**SUBMITTAL OF PLANS FOR CAPPING THE REMAINDER OF VAULT ONE, Z-
AREA SALTSTONE FACILITY (IWP-217) (U)**

Design Change Package Continuation Sheet

OCP No. -C-DCP-Z-93001

SALTSTONE VAULT #1 ISOMETRIC

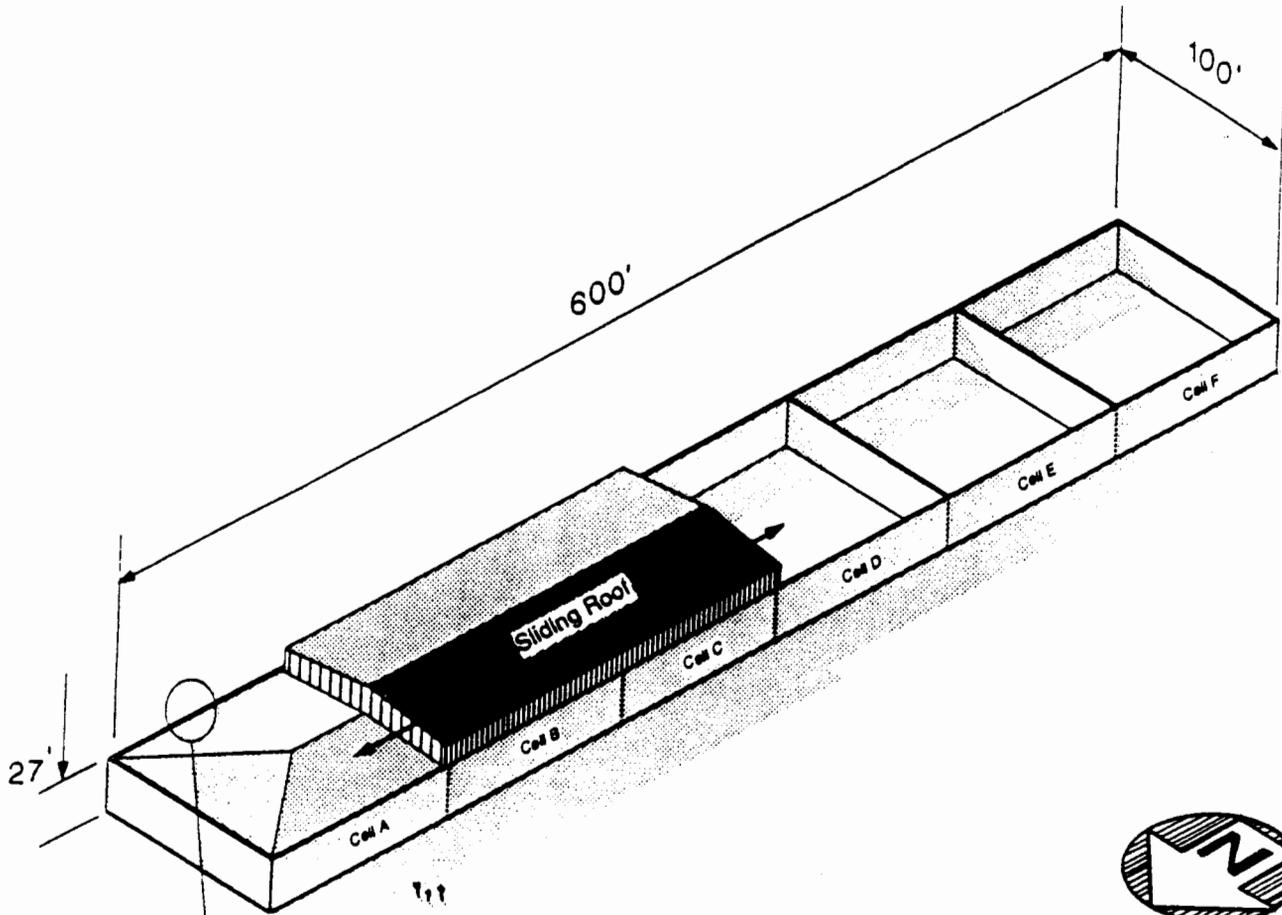
See Detail 1 for an enlargement of this area.

DETAIL

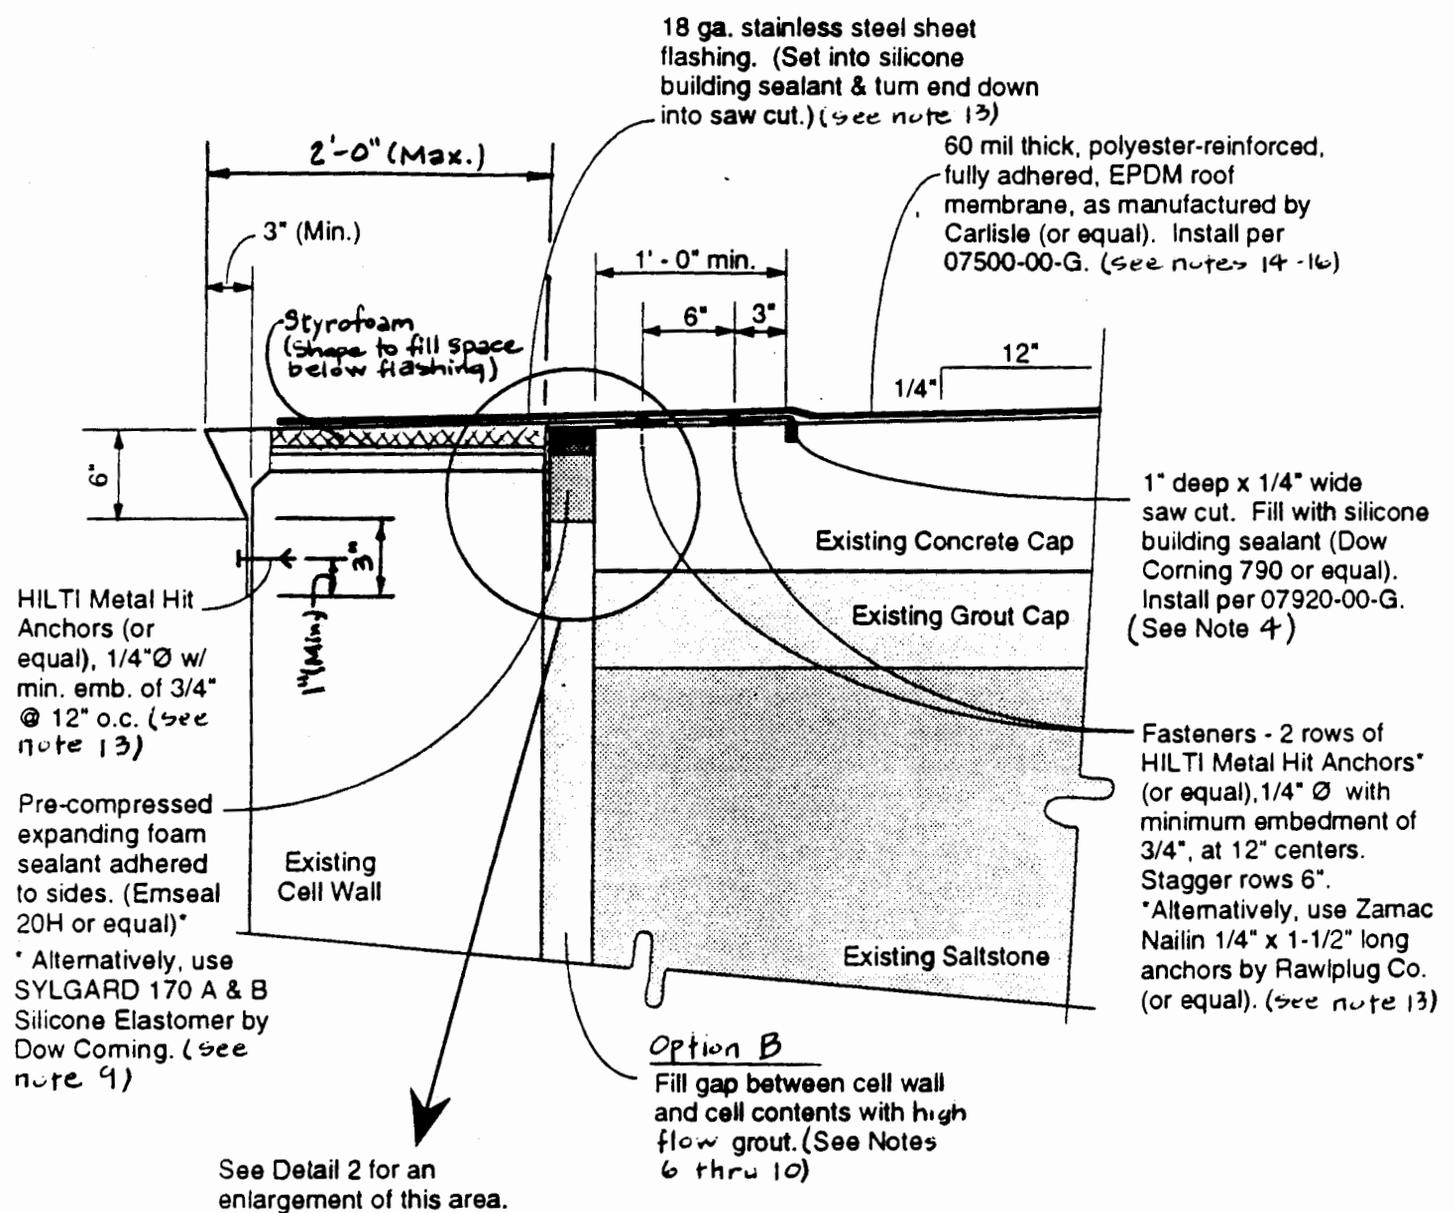
Since the original design for capping cell A of Saltstone Vault No. 1, as shown on drawing C-CC-Z-0010, has been changed due to lessons learned during the construction phase of cell A, the remaining cells (B through F) need a new design.

The capping of Cells B through F shall be completed in accordance with Drawing No. C-CC-Z-0010, sketches on pages 2 through 4 of this DCP, and with the requirements listed below.

There are two options provided. **Option A assumes there is essentially no gap between the vault wall and the interior grout/concrete layers. Option B assumes that there is a gap.** (Note: If Option A or Option B are not shown with a note, then the note applies to both options).

3. Place the 6" reinforced concrete layer in accordance with Drawing No. C-CC-Z-0010. **Option A:** Place a 2" x 5-1/2" expansion joint strip and a 2" wide x 1/2" deep (max.) filler strip (on top), wrapped in a plastic bond-breaker sheet, at the edge of this layer. These 2" wide strips shall be placed flush with the inside face of the cell wall and up to the top of the existing vertical embedded plate.

DETAIL

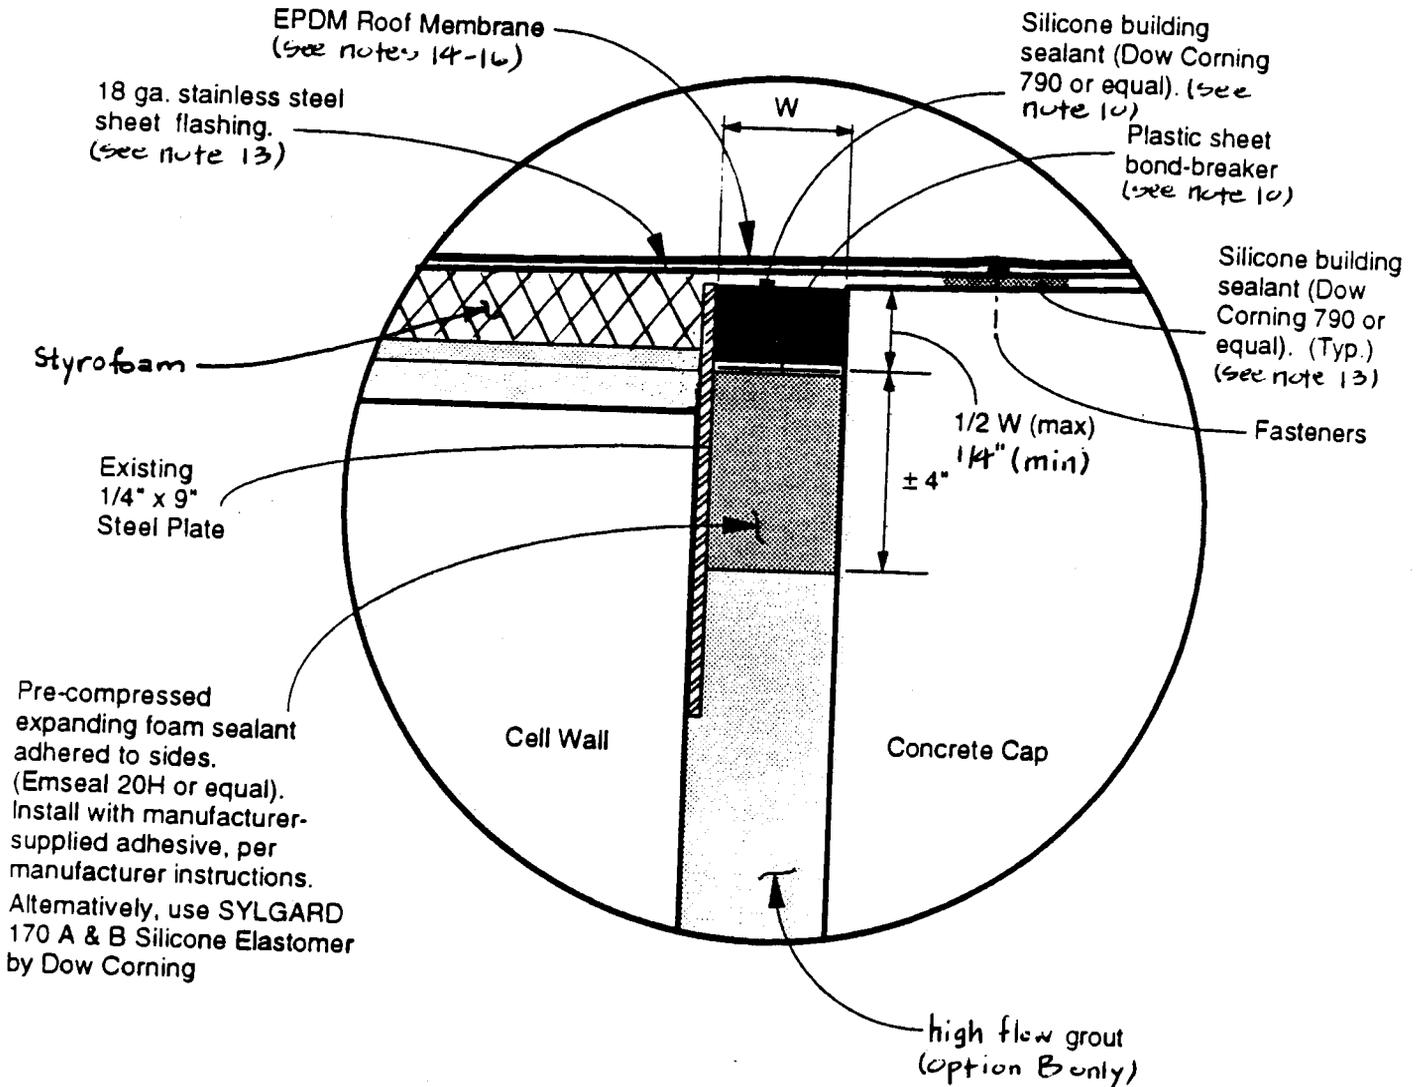
9. **Option B:** In the gap between the clean grout/reinforced concrete layers and the existing vault wall, install Emseal 20H expanding foam strips (or equal). Alternatively, SYLGARD 170 A & B silicone elastomer by Dow Corning may be used. Install in accordance with manufacturer's instructions. For Emseal, use manufacturer-supplied adhesive on both sides of the gap. Use appropriately sized material for width of gap.

10. **Option B:** Insert plastic bond-breaker sheet on top of expanding foam strips (or existing expansion joint material) prior to installing the single component silicone building sealant. Sealant shall be Dow Corning 790 silicone building sealant (or equal). Depth of sealant shall not exceed 1/2 the width of the gap width. Ensure placement of bond-breaker sheet does not prevent adherence of sealant to sides of gap.
